Subject: Virgil C. Summer Nuclear Station  
Docket No. 50/395  
Operating License No. NPF-12  
SPDS Digital Isolator

By a letter dated April 18, 1985 from Mr. O. W. Dixon, Jr., to Mr. H. R. Denton, South Carolina Electric and Gas Company (SCE&G) provided responses to NRC Staff questions on the Virgil C. Summer Nuclear Station Safety Parameter Display System (SPDS). As a result of further NRC review of that submittal, a question was raised about one of the qualification tests for the Rochester Instrument digital isolators. This letter is hereby provided in response to that NRC Staff concern.

# ATTACHMENT A

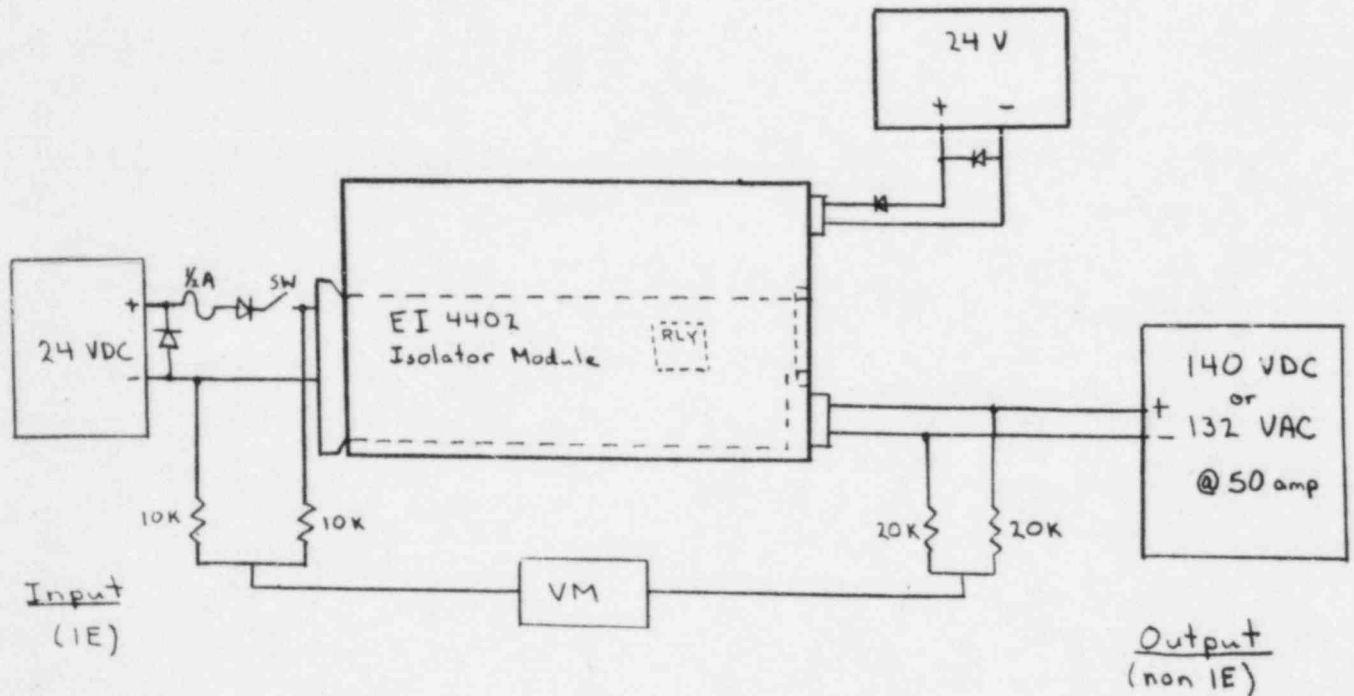
Test number two described on page 3 of Attachment A to the April 18, 1985 letter was determined by the NRC Staff to be an inadequate test for isolation for the digital isolators being used at the Virgil C. Summer Nuclear Station. Therefore SCE&G requested further test data from the isolators' manufacturer. As a result, the data resulting from the test set-up shown in Attachment A to this letter was provided to SCE&G by the manufacturer. This data supports that, even in the event of the maximum postulated credible fault which these isolators would be exposed to at the Virgil C. Summer Nuclear Station, isolation is maintained between the non-1E and 1E outputs and inputs of the system as described in the April 18, 1985 letter.

140 VDC Tests - Relay contacts on non IE side of isolator module fused closed. Circuit traces opened. Isolation was maintained.

132 VAC Tests - Relay contacts remained undamaged. Circuit traces opened. Isolation was maintained.
